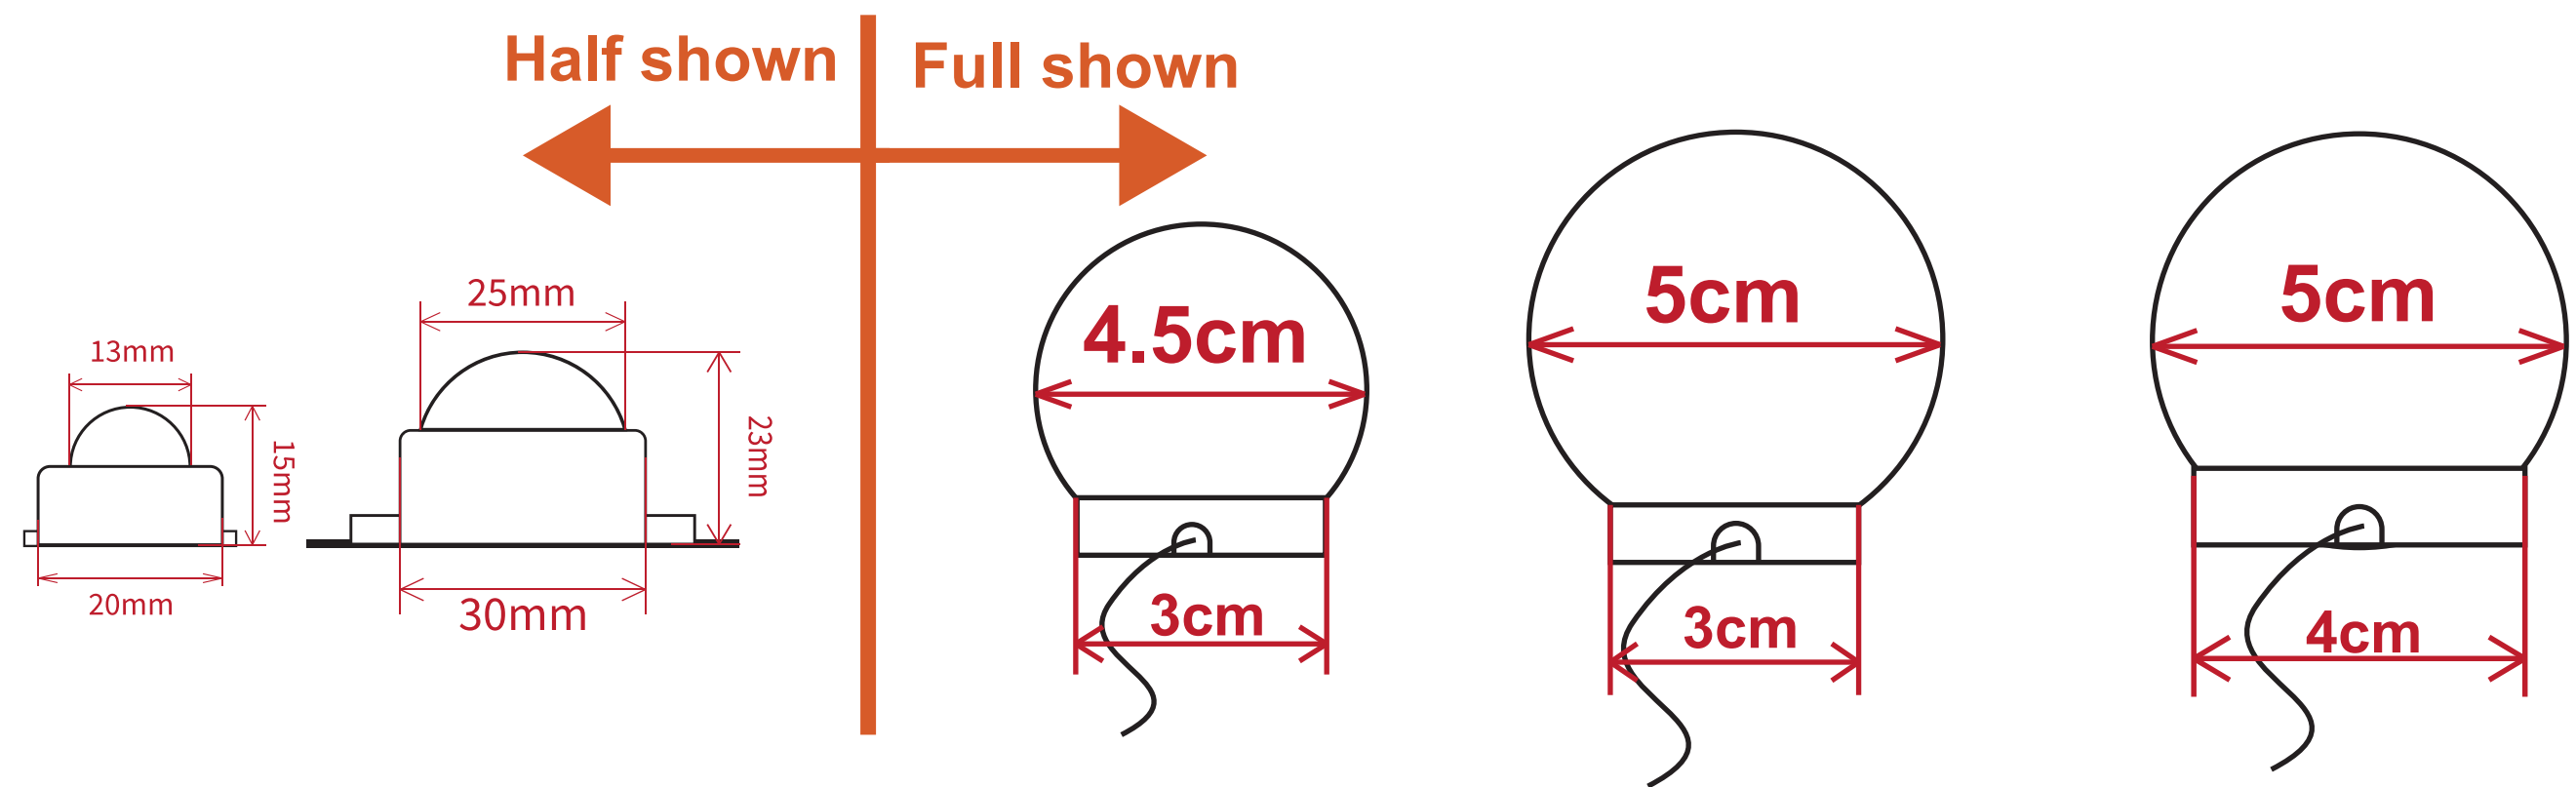
Recommended stroke needs to be 10mm larger than bulb size

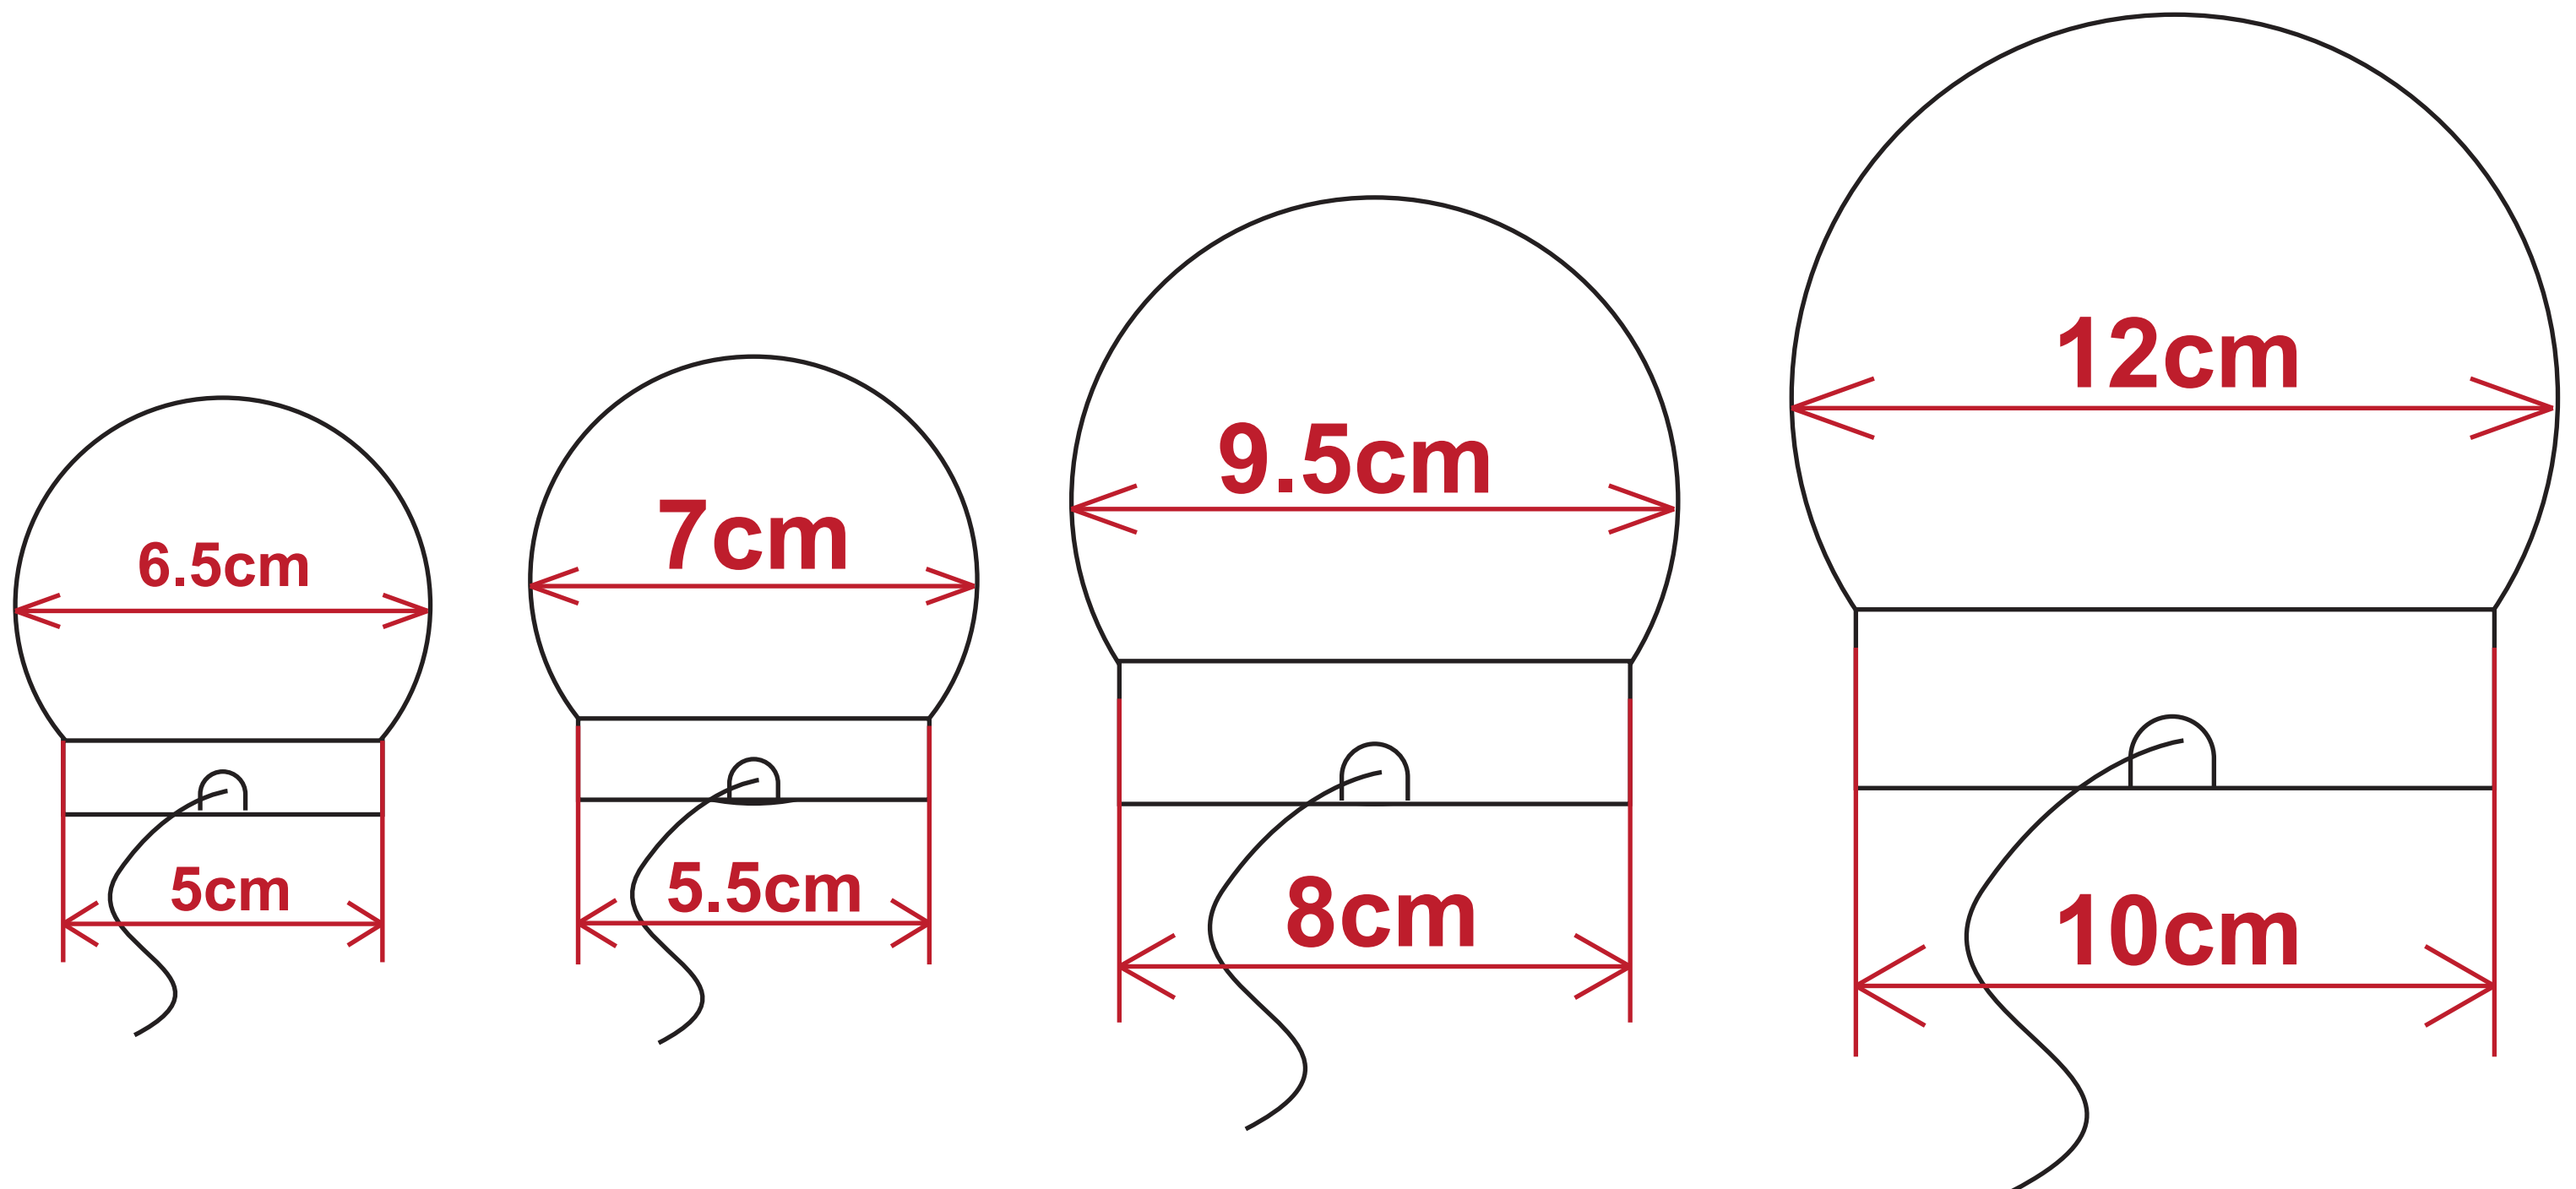
Recommended stroke needs to be 10mm larger than bulb size
